South Texas Project  
Units 3 and 4  
Docket Nos. 52-012 and 52-013  
Revised Response to Request for Additional Information

RAI 03.07.01-29, Supplement 1, Revision 1

**RAI 03.07.01-29, Supplement 1, Revision 1****QUESTION:**

Figure 03.07.01-29 S1.1: Interaction Node for the Modified Subtraction Method

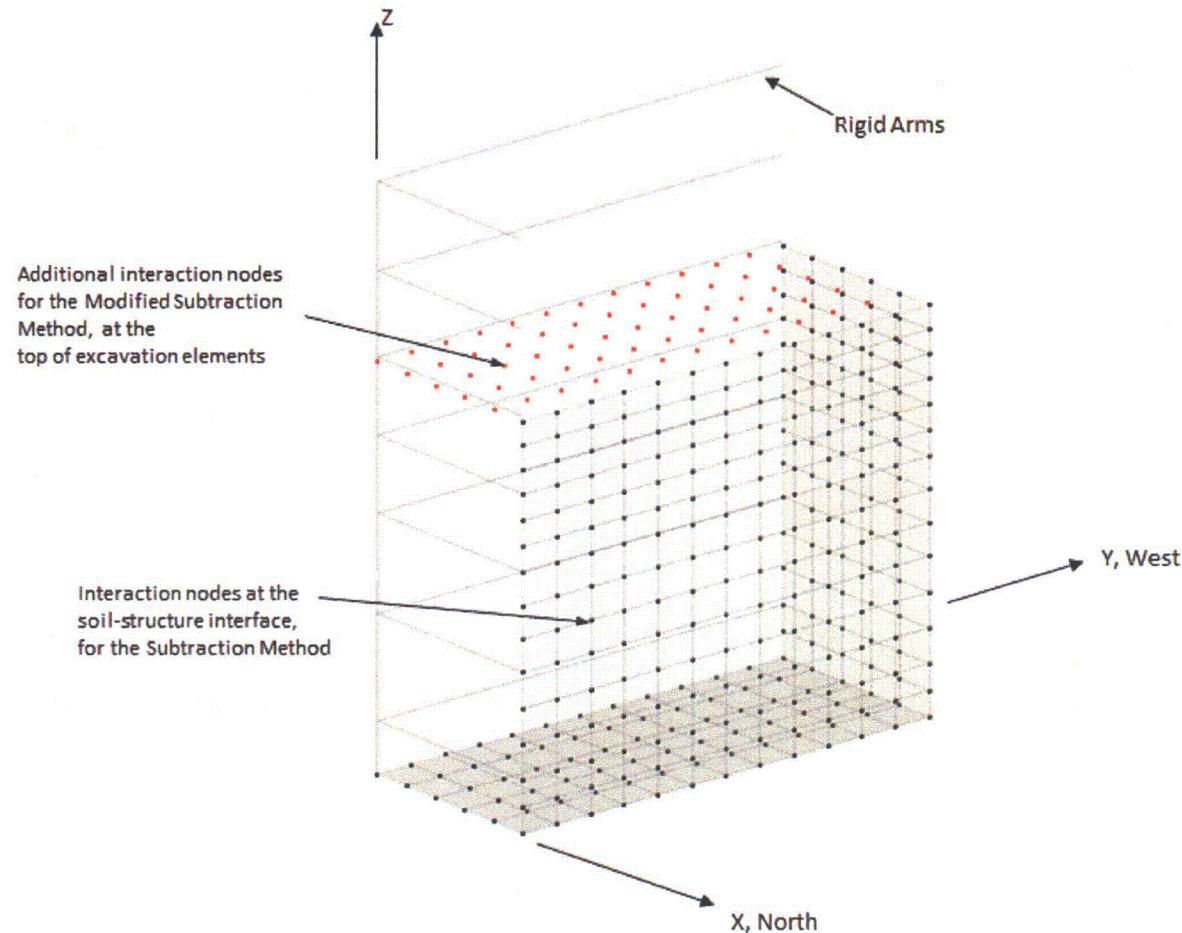
In RAI response, provide explanation of "modified subtraction model" -- state that all surface nodes are included (**Punch List Item 114**)

Modified Subtraction Method, similar to the Subtraction Method, uses a subset of the interaction nodes that are used in the Direct Method. In this method, number of interaction nodes lies between those for Subtraction and Direct Methods of analysis. For all STP 3 & 4 models, the interaction nodes for Modified Subtraction Method of analysis are comprised of all those at the soil-structure interface and all those at the top of excavated

soil elements. An example is shown in Figure 03.07.01-29 S1.1 for the Control Building (CB).
